**Lauderhill City Center
Responses to Statement of Information Needed
(First Round)**

Submitted on behalf of:

LM TIC I LLC, LM TIC II LLC, LM TIC III LLC, LM TIC IV LLC, and LM IDEAL, LLC,
LM TIC I LLC, LM TIC II LLC, LM TIC III LLC, LM TIC IV LLC, and LM IDEAL, LLC

December 19, 2008

2007 NOISE CONTOUR MAP – FORT LAUDERDALE EXECUTIVE AIRPORT

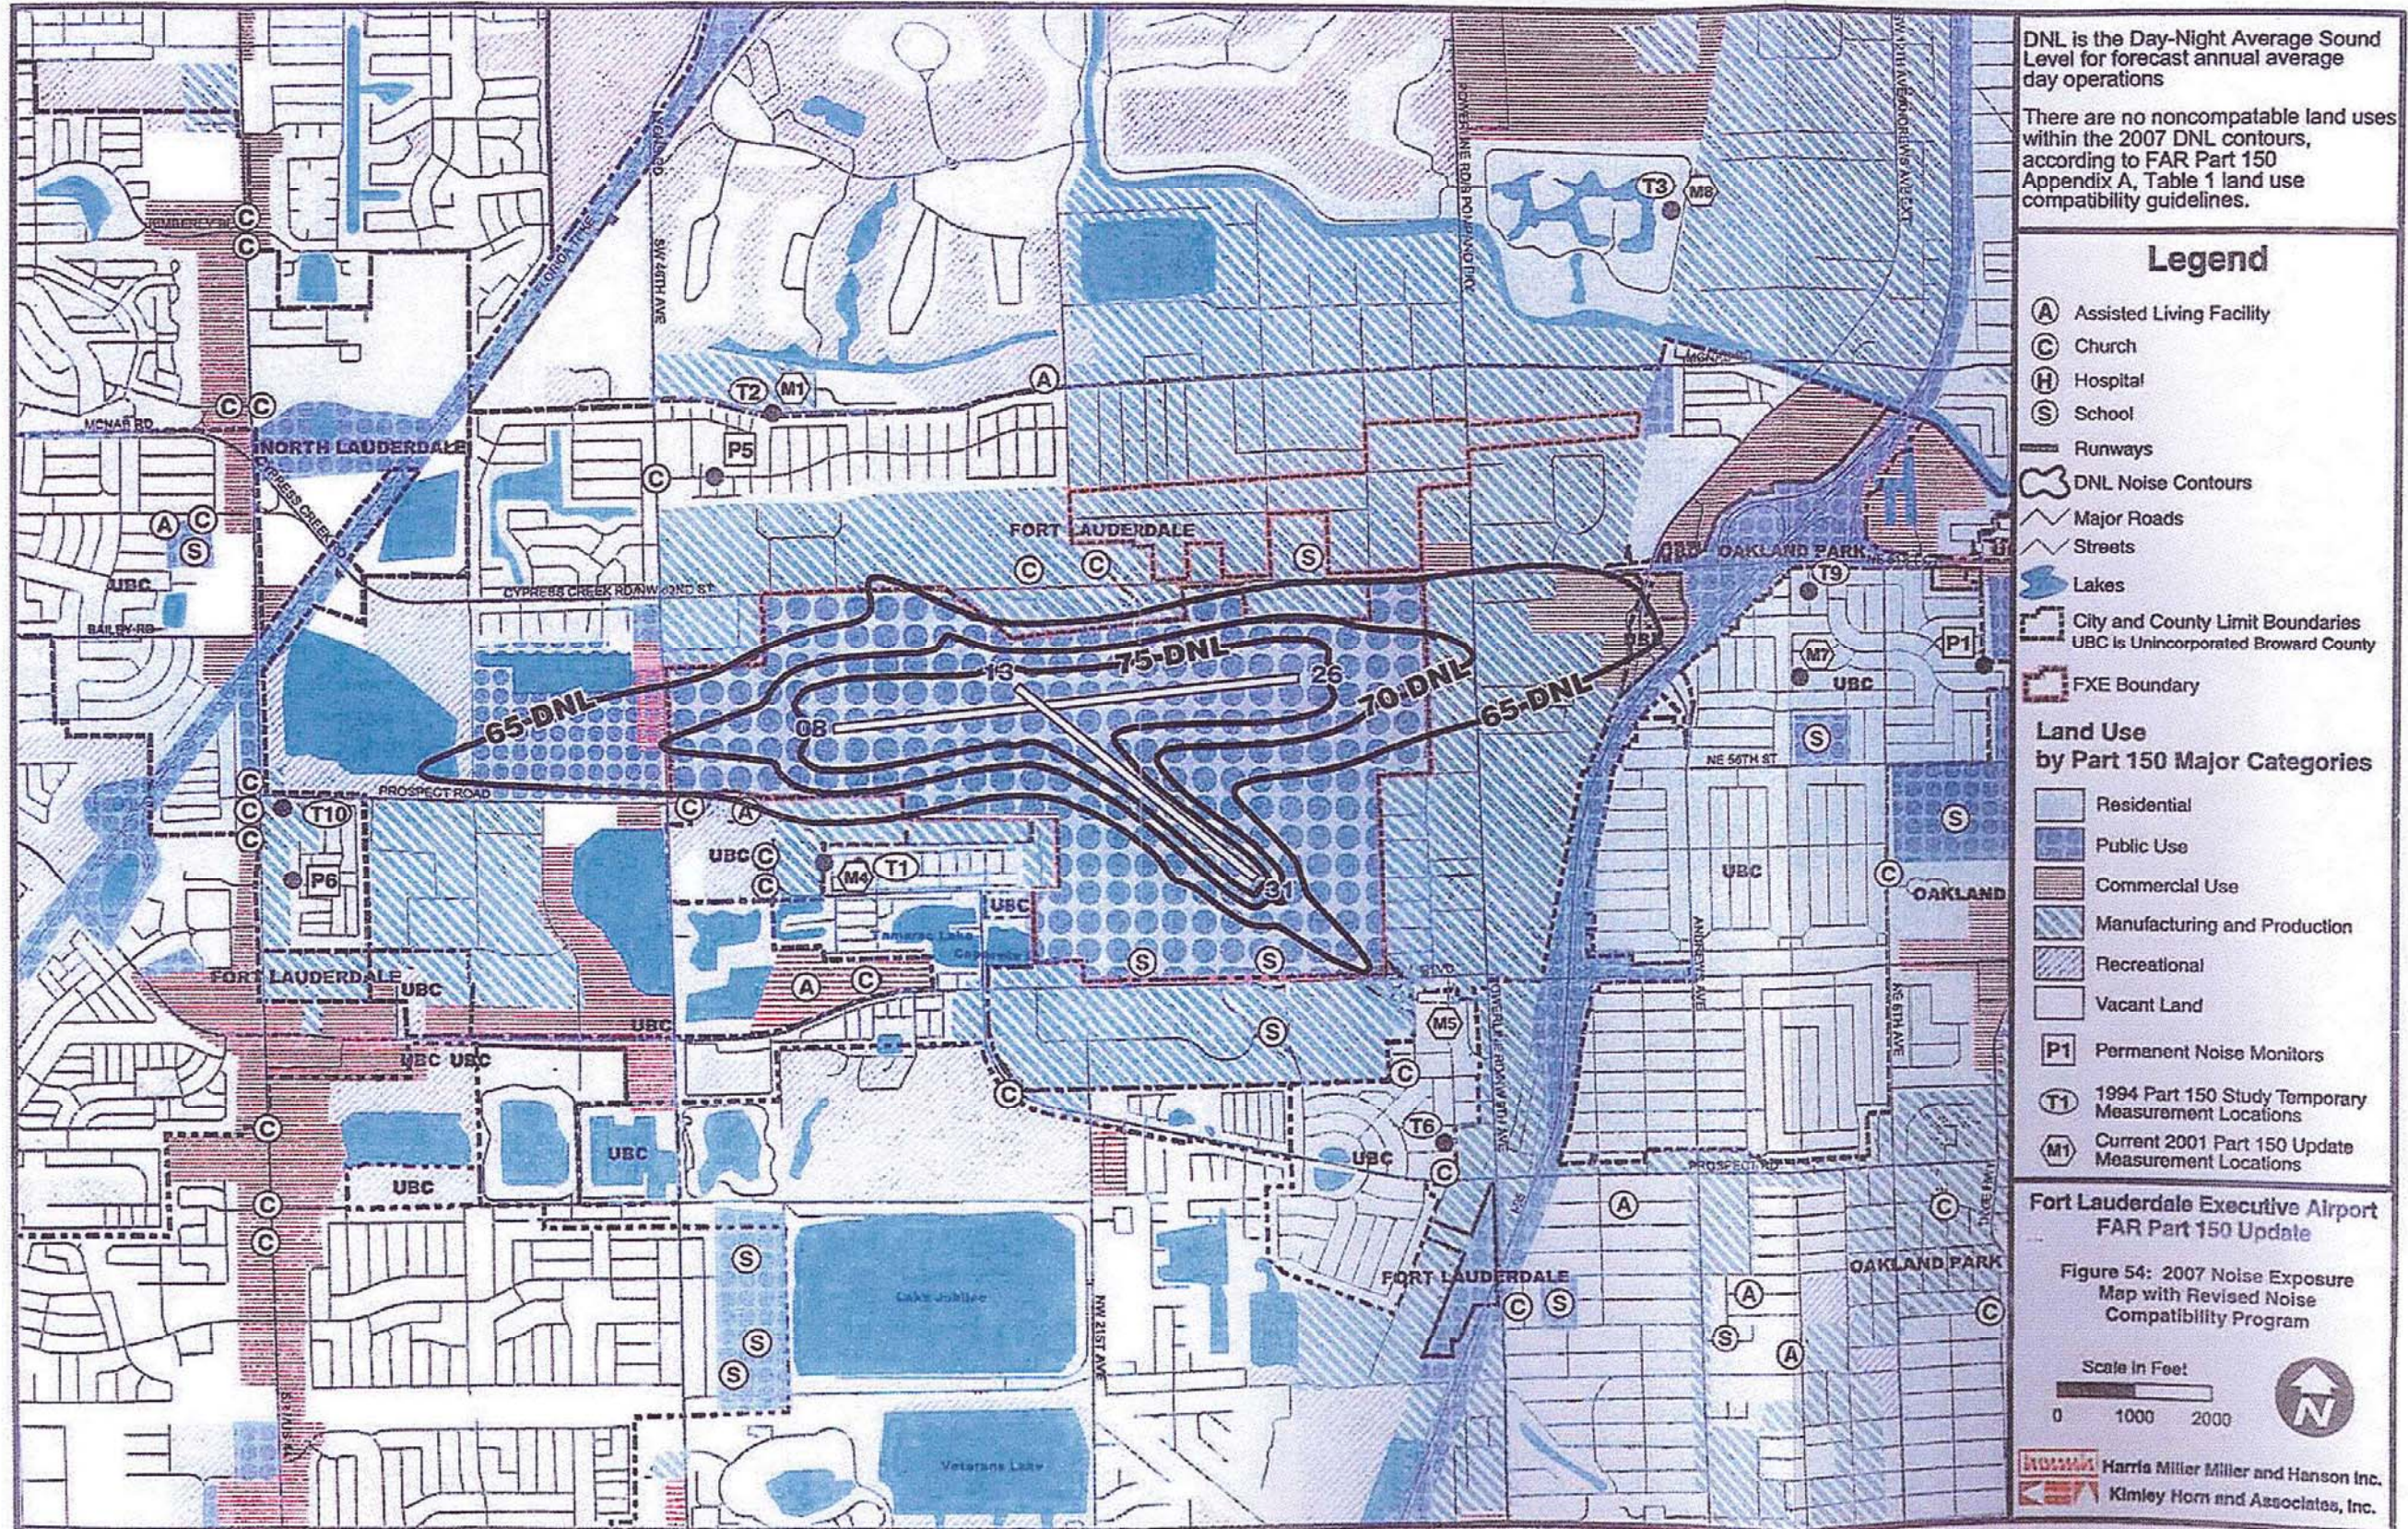
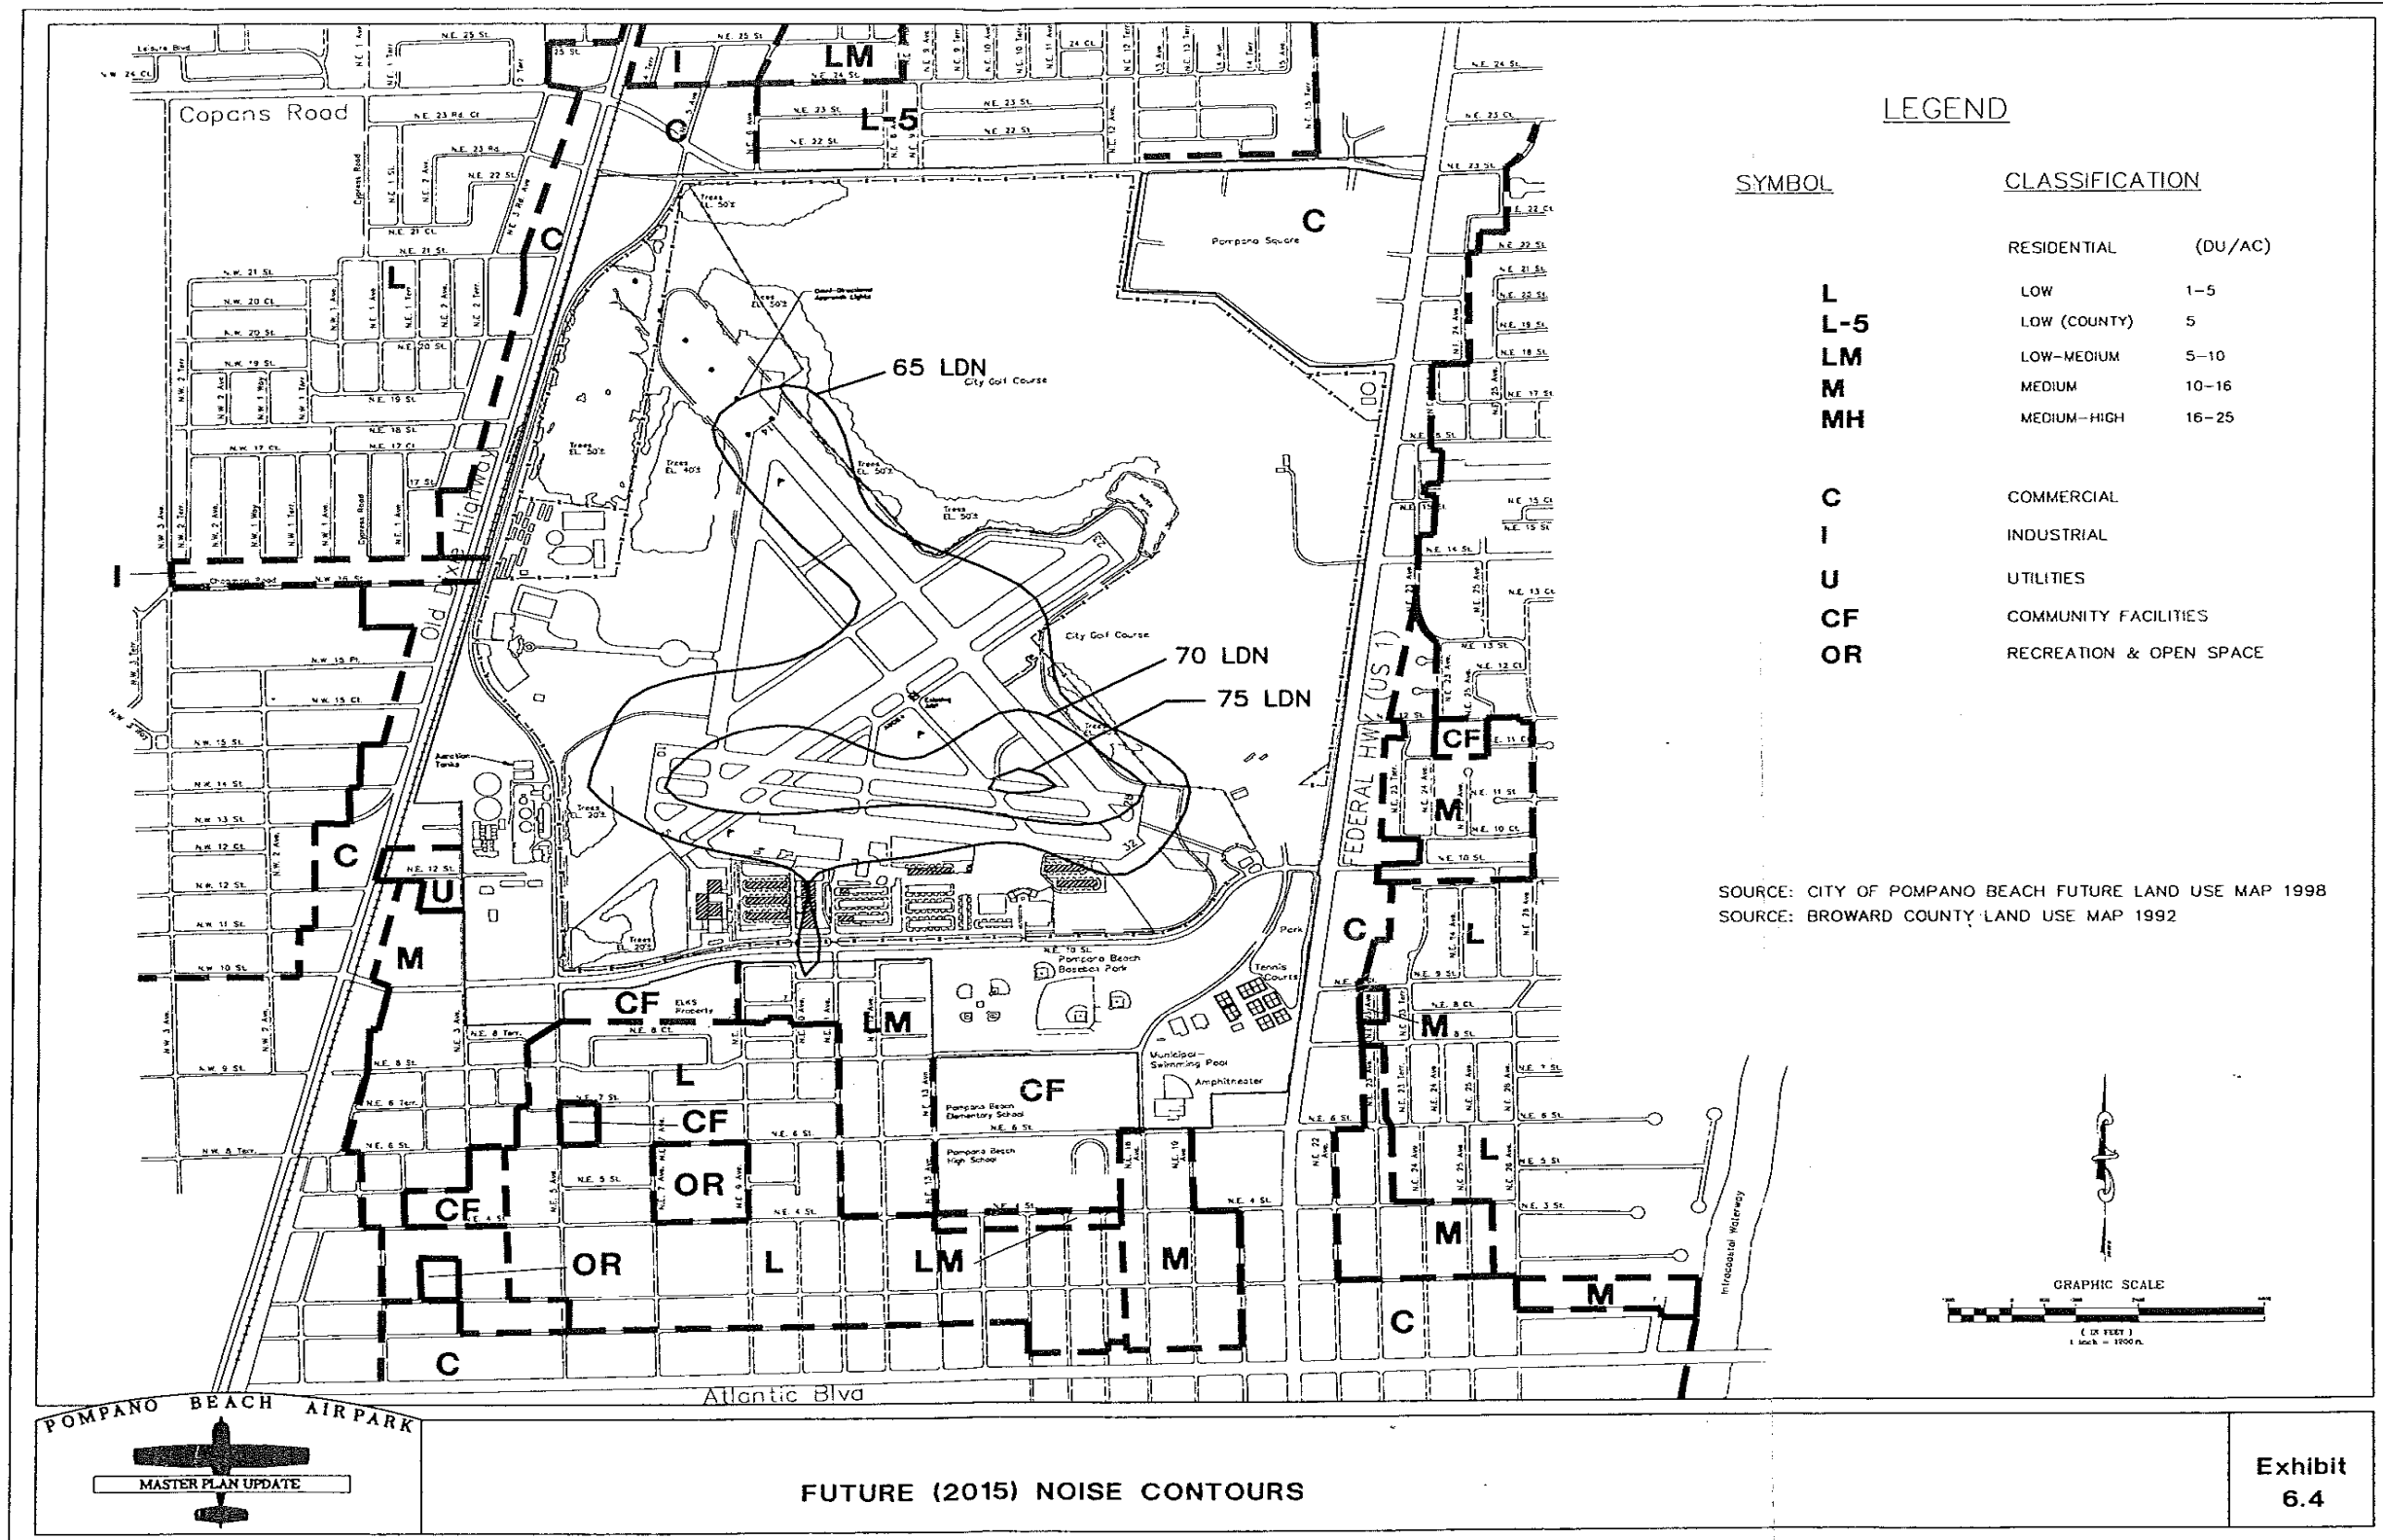
Comment: The Applicant's response appears to be insufficient because the noise contour maps are illegible. Please resubmit in a large size so that the text is readable. In addition, please label major roadways on General Location Map.

Applicant's Response: *Larger noise contour maps have been attached as Composite Exhibit H. The revised General Location Map has been attached as part of Composite Exhibit A.*

OPEN SPACE AT PROJECT BUILDOUT

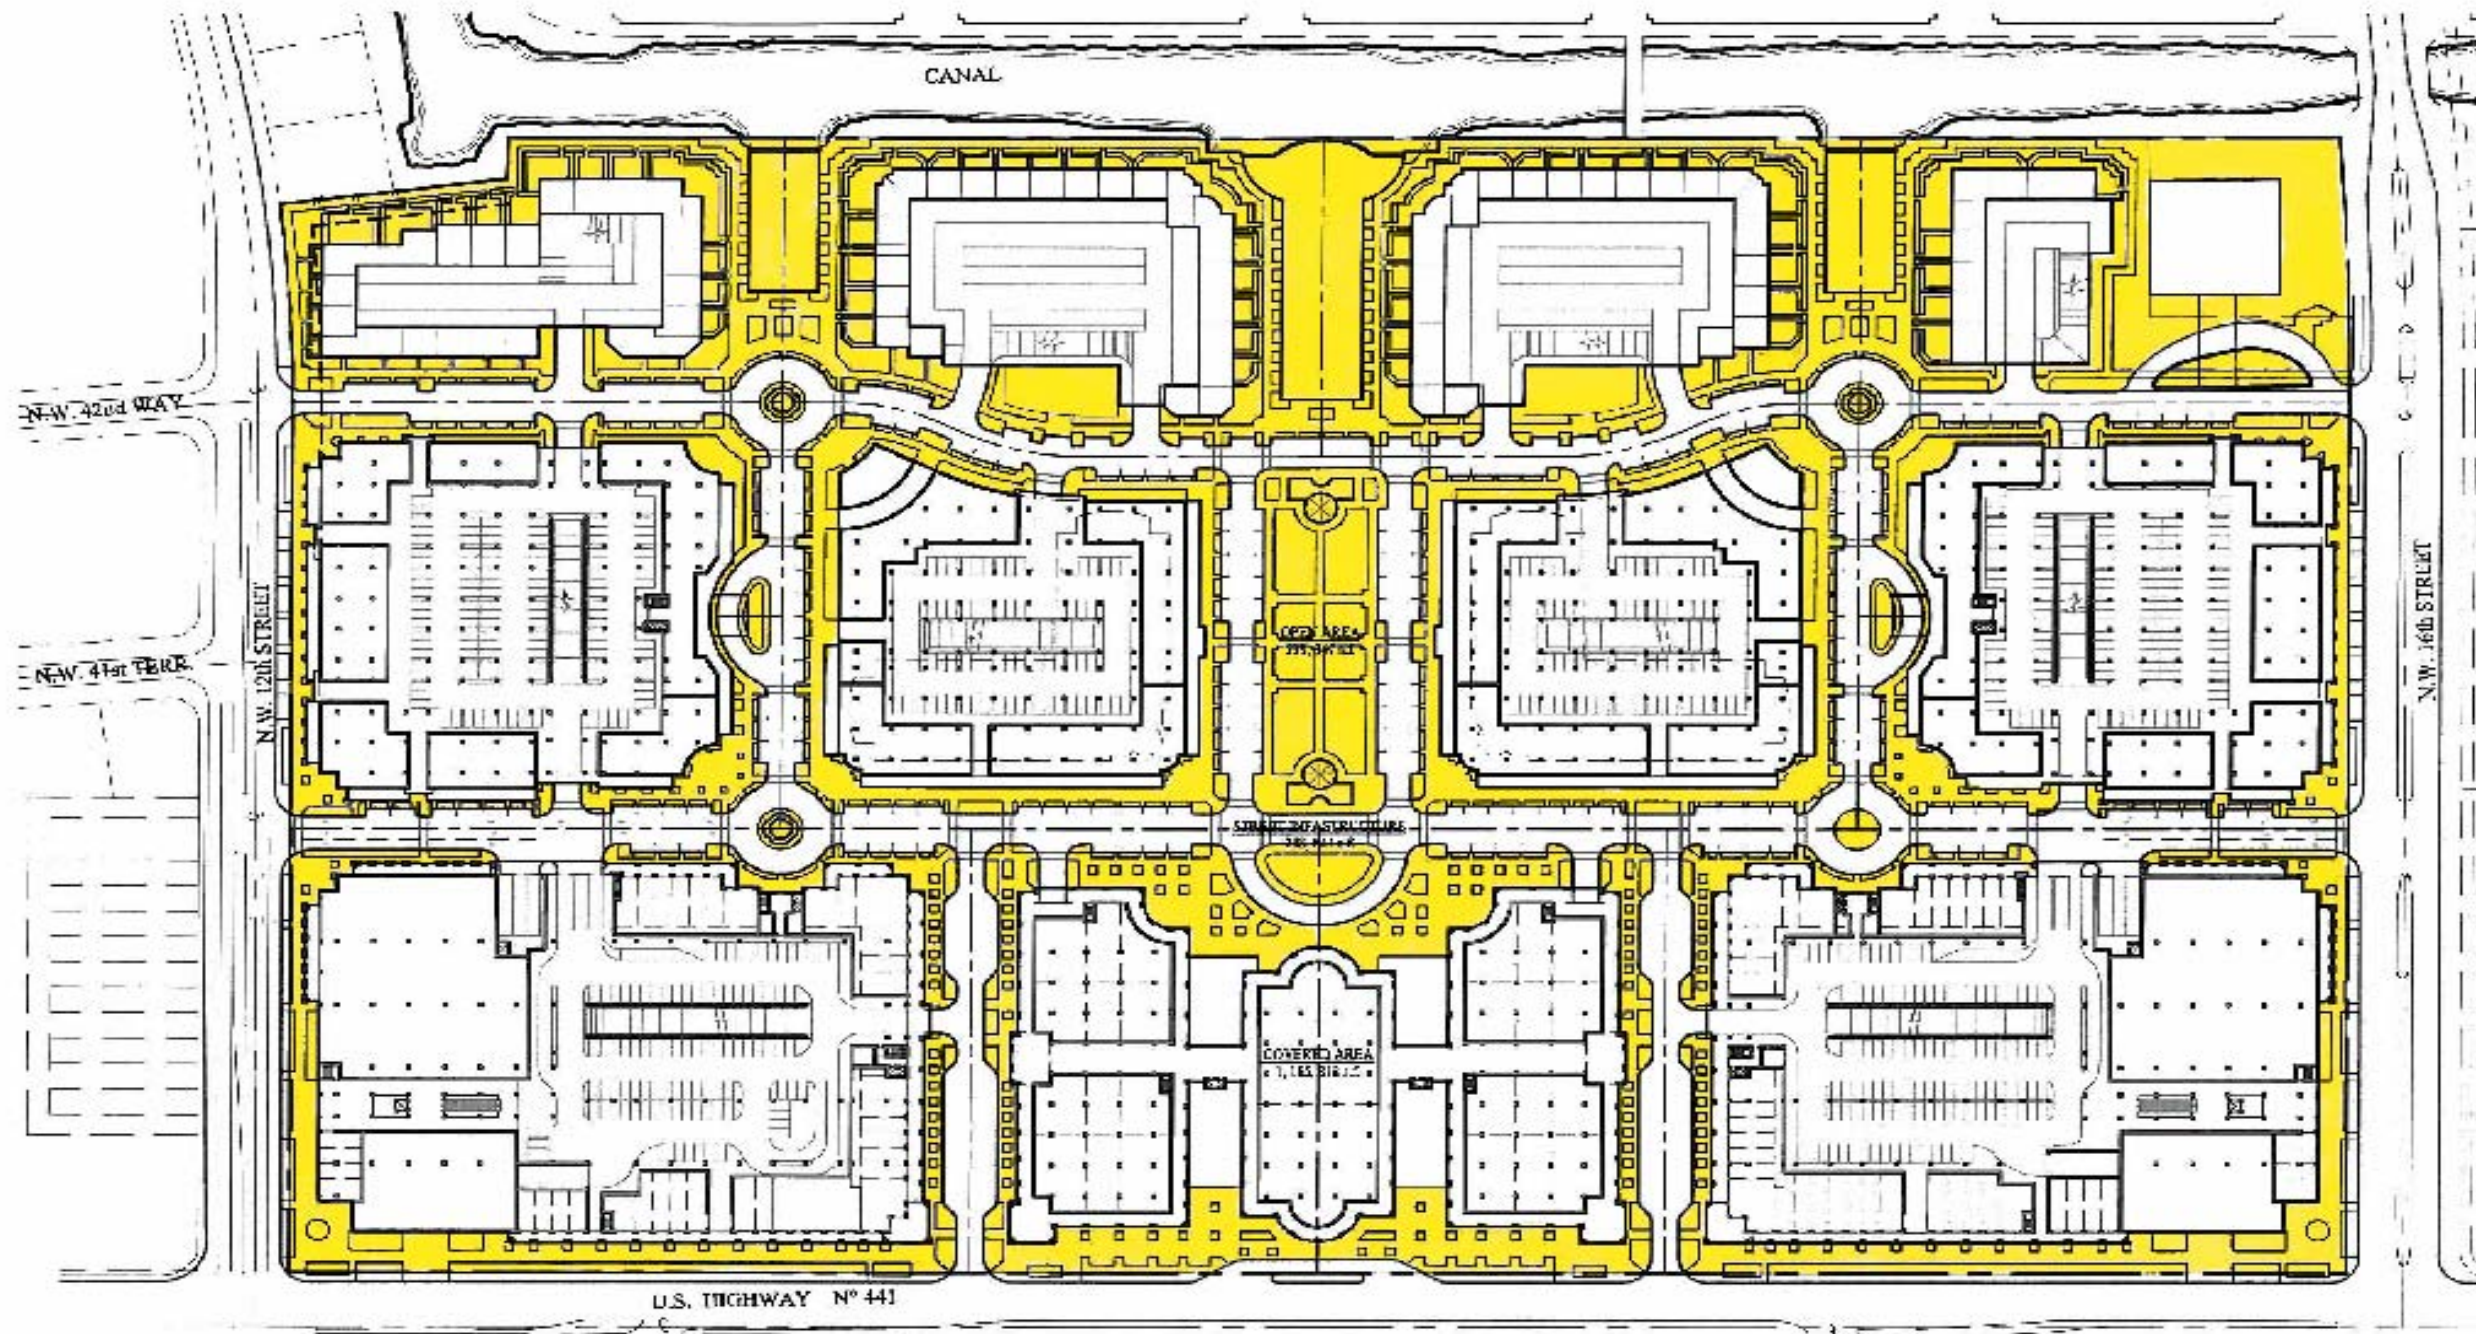
Comment: The Applicants response is insufficient because Section A provides insufficient discussion and/or visual representation of what will be included as open space, particularly as it relates to the residential development. The discussion is limited to what the open space does not include. The Applicant has proposed this project as a Transit Oriented Corridor development, therefore, additional information on open space components is required.

Sidewalks are not defined as open space. The definition of open space, and level of service for open space, is established in the City of Lauderhill's Comprehensive Plan. Applicant is requested to recalculate the total acreage that will be dedicated to open space (not including sidewalks) and to include discussion of urban open space or green space/pocket park uses integrated with the Transit Oriented Corridor and will promote recreational opportunities.

Applicant's Response: *The project has limited traditional open space, such as parks or large fields, because it is a high density, compact, urban development. Excluding sidewalks, the Lauderhill City Center will provide approximately 250,212 square feet of open/green space (as depicted on the figure attached as part of Composite Exhibit D). The project has been planned in such a manner to ensure that it would become a true transit-oriented development (TOD), containing high densities that focus the local population around a transit station. This is in stark contrast to the ubiquitous sprawl model seen throughout South Florida where large suburban tracts have been developed with low density*
